**TERMINAL BUILDING: MEMORANDUM OF UNDERSTANDING AND ADMINISTRATIVE
MODIFICATION DATABASE**

Prepared by Jensen Hughes: April, 19, 2017

This document has been prepared by Jensen Hughes at the request of DEN. This document addresses all identified MOUs from 1990 through 2016 associated with the Terminal Complex at the Airport. It is intended to identify the scope of these MOUs and to identify whether they have been partially or completely superseded or if the MOU remains in effect. Note that superseded MOUs are often recommended to be retained for historic information.

LEVEL 5 TERMINAL
 FIRE ALARM ZONES
 SMOKE ZONES
 SPRINKLER ZONES

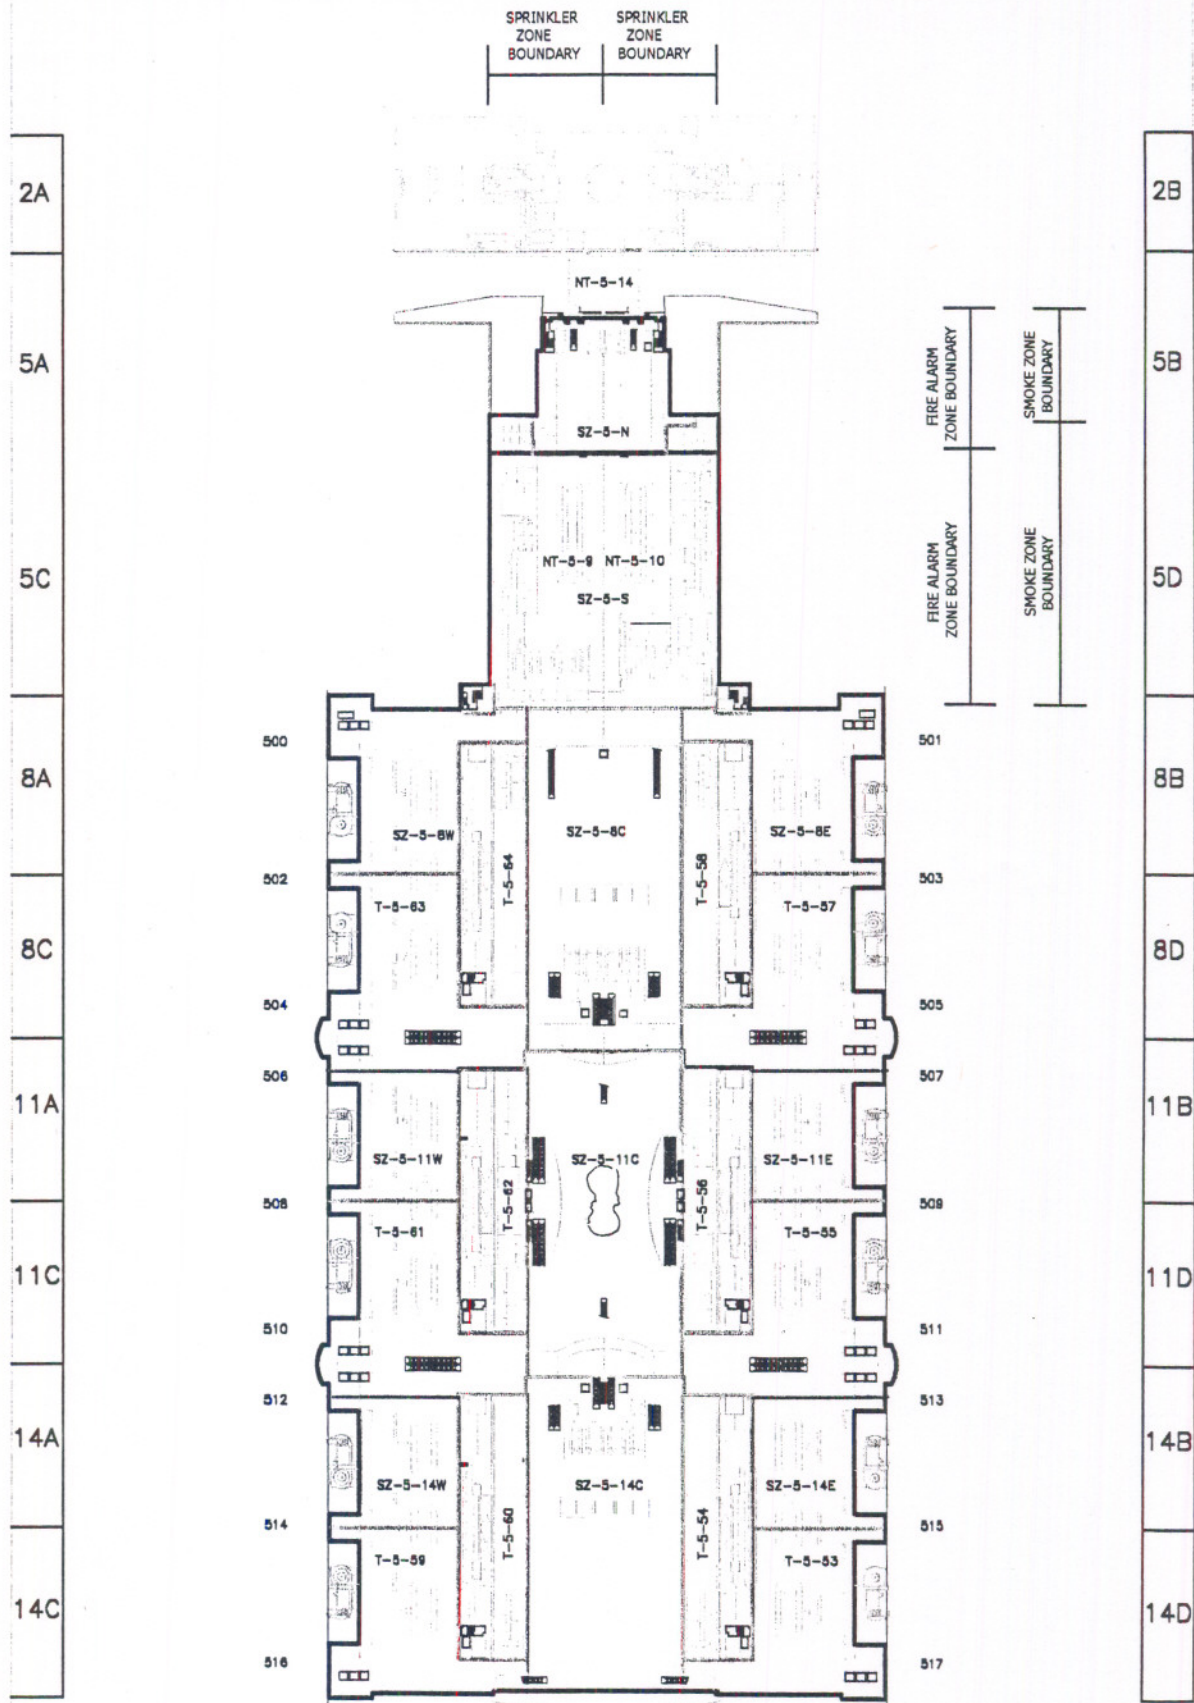
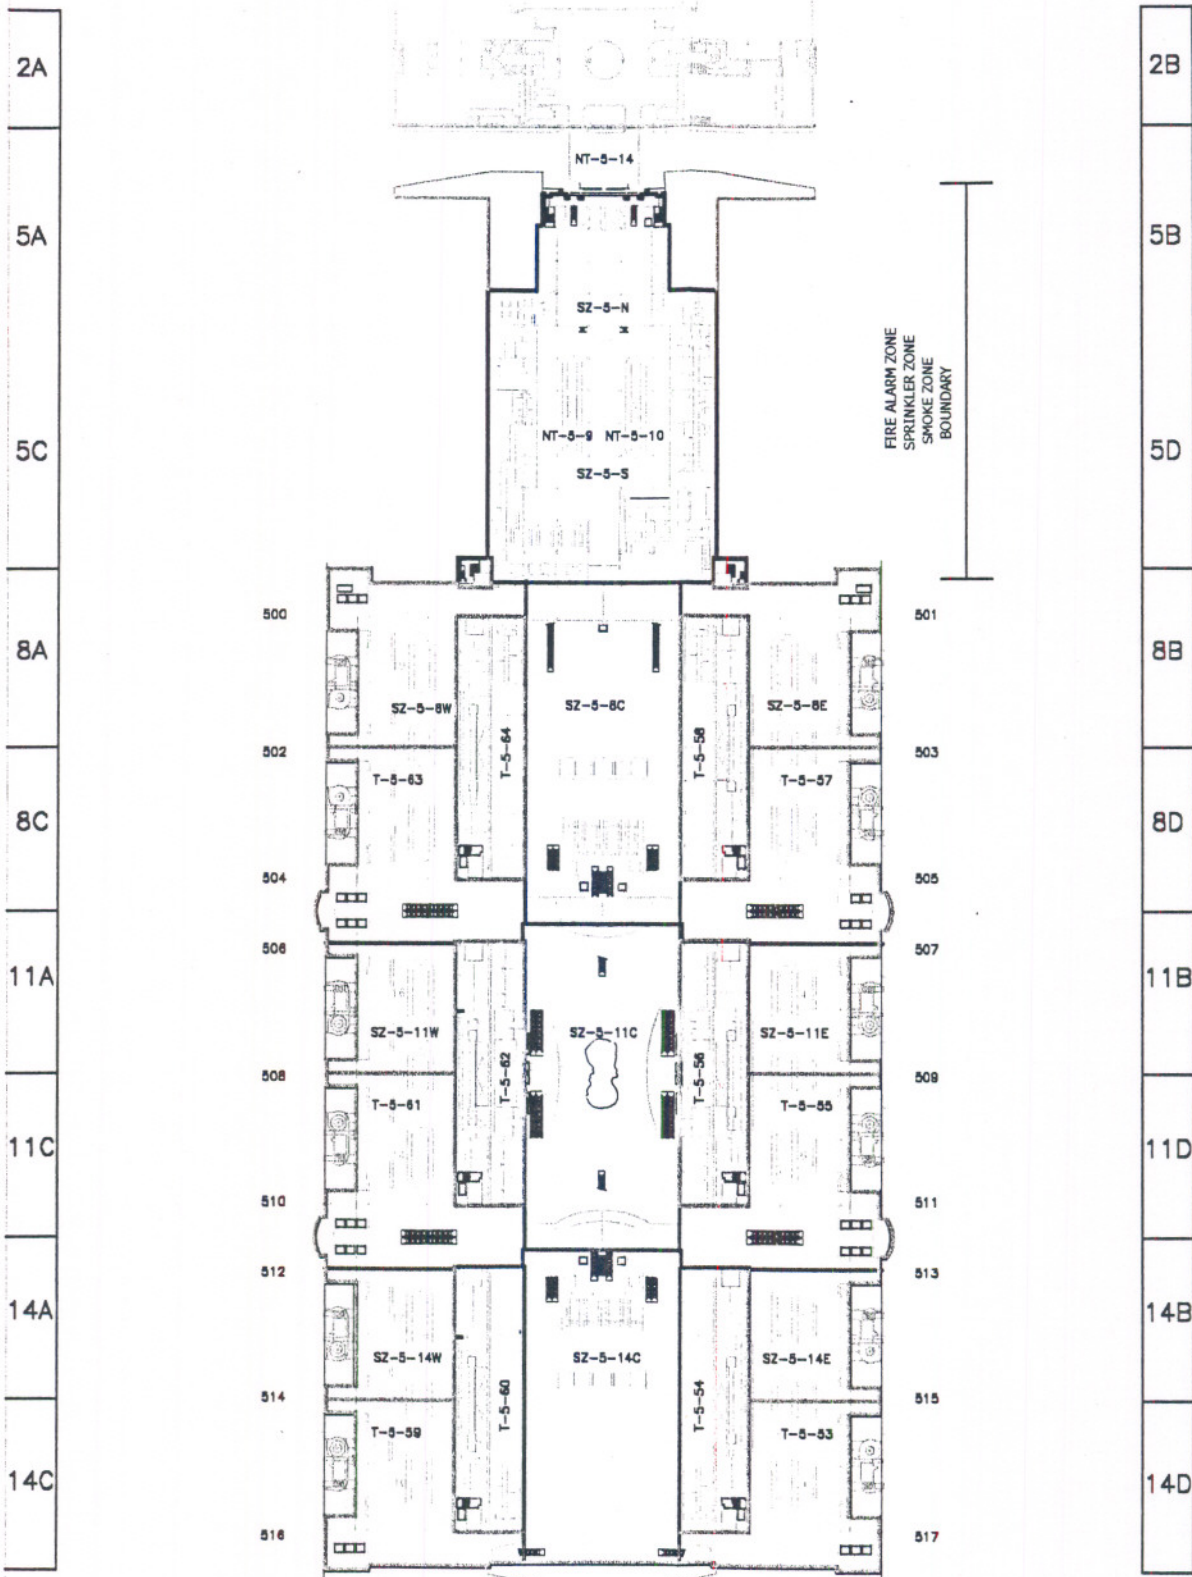
02020600.pdf	February 6, 2002	Terminal Building Level 5 Customs Area - Modification to Fire Alarm, Fire Protection and Smoke Zones	Robert Busch, Design Manager, Life Safety Team	David Clark, DFD Chief Fire Protection Engineer	Requests to combine two smoke control zones serving the Terminal Level 5 Customs Area into a single smoke control zone, since the zoning of the smoke control, automatic sprinklers and fire alarm system were not consistent. Approval was granted.	Still Applicable	The alignment of the various zones is being addressed by the fire alarm project. Approval of project drawings, which include the various fire/smoke zones, will obviate the need for this MOU.	Retain MOU 02020600 until completion of fire alarm project, then delete.	Terminal

**DIA Terminal - Thermal Override Issue
 Scenario A**

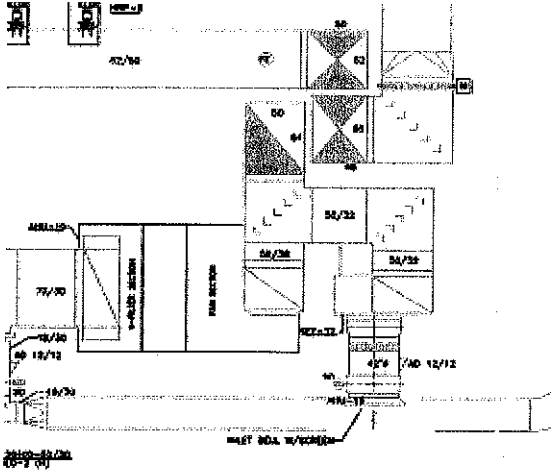
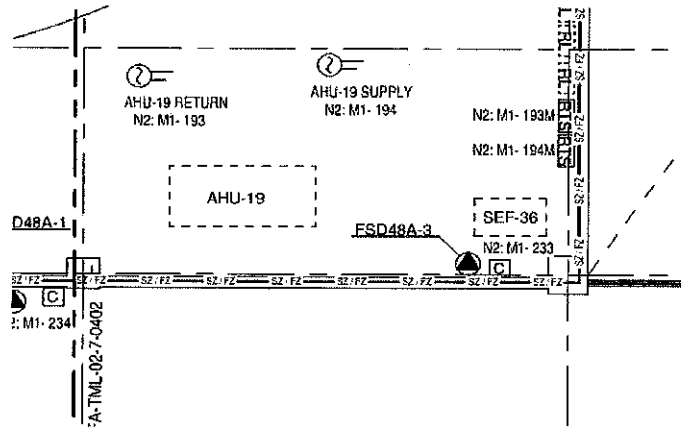
Current Sequence of Operations:

When fan is activated, thermal override control module was activated.

Proposed Sequence of Operations:

Replace EST module with Simplex module.

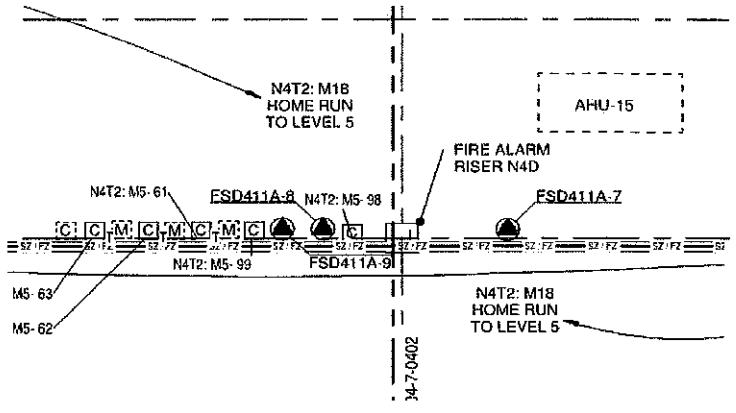
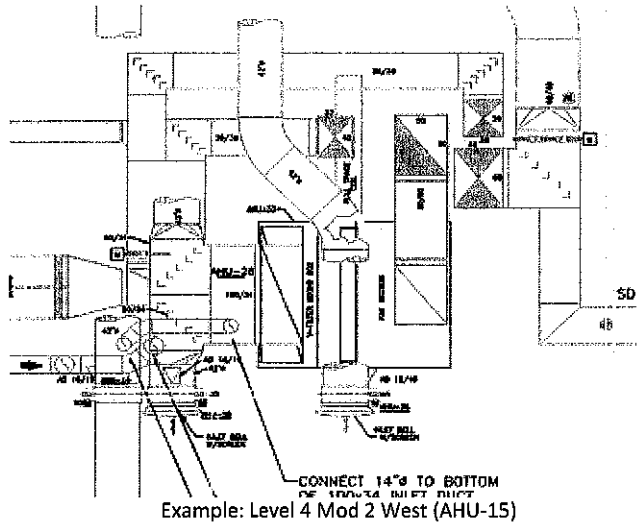
When fan is activated, thermal override control module was activated.

Proposed Sequence of Operations:

- Demo EST module.
- Decommission thermal override by placing tag on damper.
- Damper will close at 165 degrees, operating as a normal fire damper.

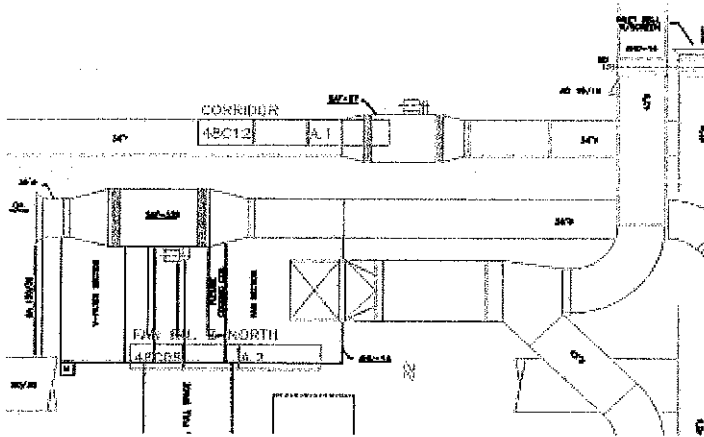
When smoke control is activated, thermal override control module was activated.
 For exhaust AHU's serving separate smoke zones, the damper control module is used to close the damper to only exhaust from the proper smoke zone.

Proposed Sequence of Operations:

Replace EST modules with Simplex modules
 Maintain existing sequence

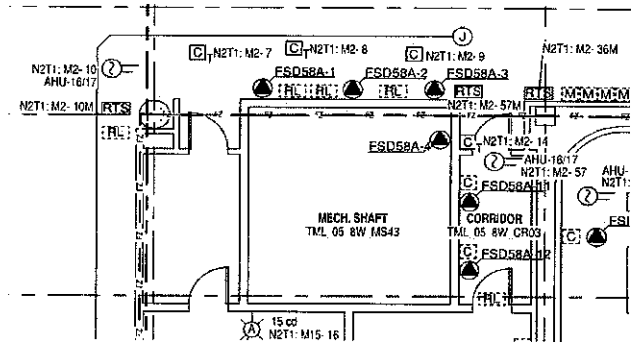
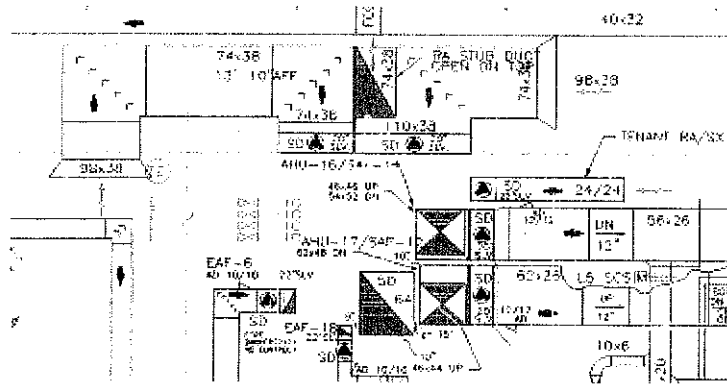
Proposed Sequence of Operations:

Replace EST modules with Simplex modules

Maintain existing sequence

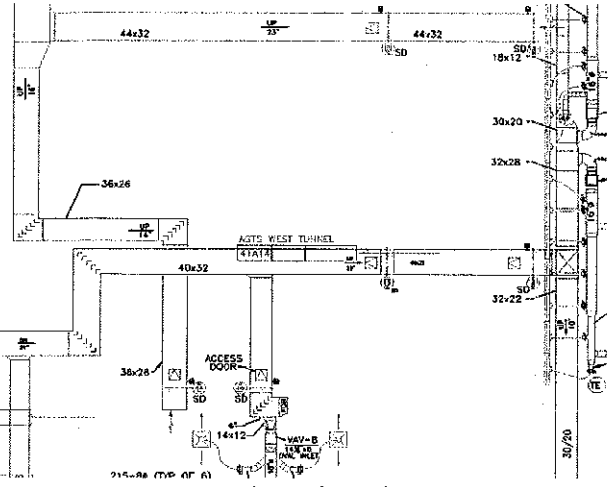
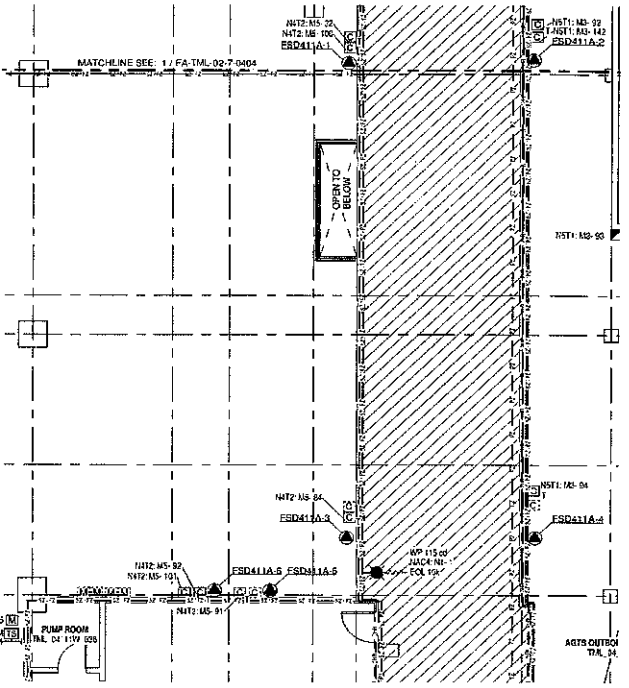
When smoke control is activated, thermal override control module was activated. Downstream control modules on downstream dampers open or close to supply make-up air to adjacent smoke zones.

Proposed Sequence of Operations:

- Demo EST module.
 - Decommission thermal override by placing tag on damper.
 - Damper will close at 165 degrees, operating as a normal fire damper.
- Demo all downstream damper control and status monitor modules.

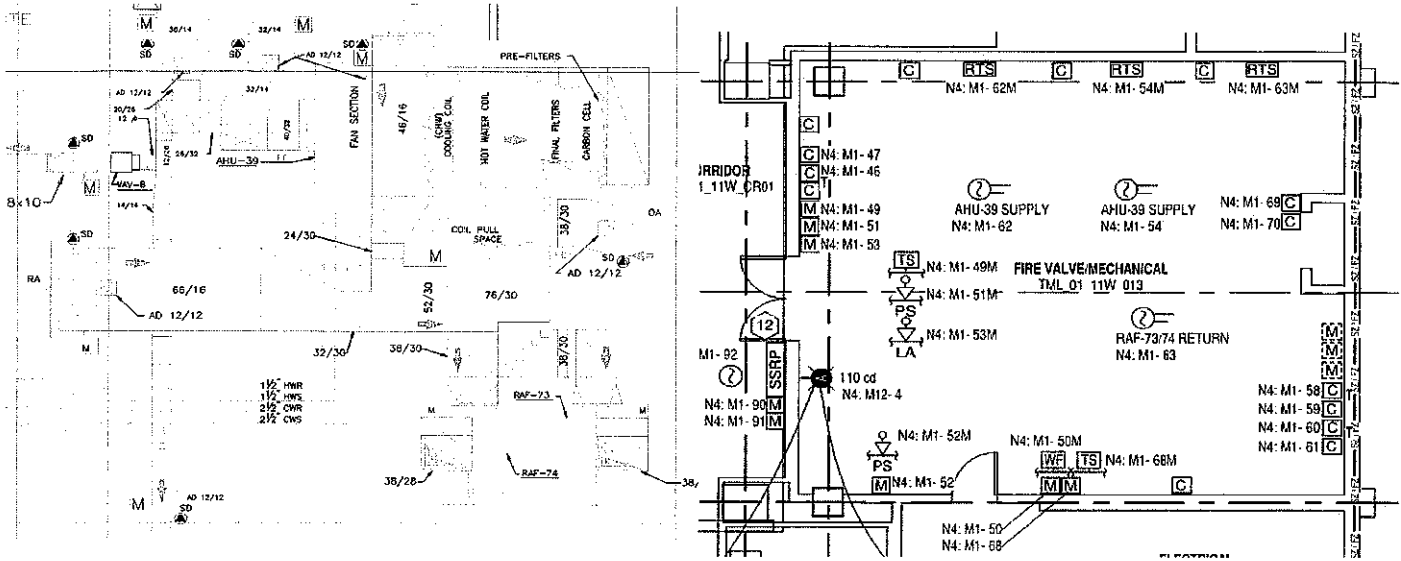
When smoke control is activated, thermal override control module was activated on exhaust duct.
 Smoke control exhaust duct dampers go open and supply duct dampers go closed. Adjacent zone dampers pressurize and close exhaust.

Proposed Sequence of Operations:

- Demo EST module on supply duct work.
 - Decommission thermal override by placing tag on damper.
 - Damper will close at 165 degrees, operating as a normal fire damper.
- Replace EST modules with Simplex modules on exhaust duct work.
- Maintain existing sequence
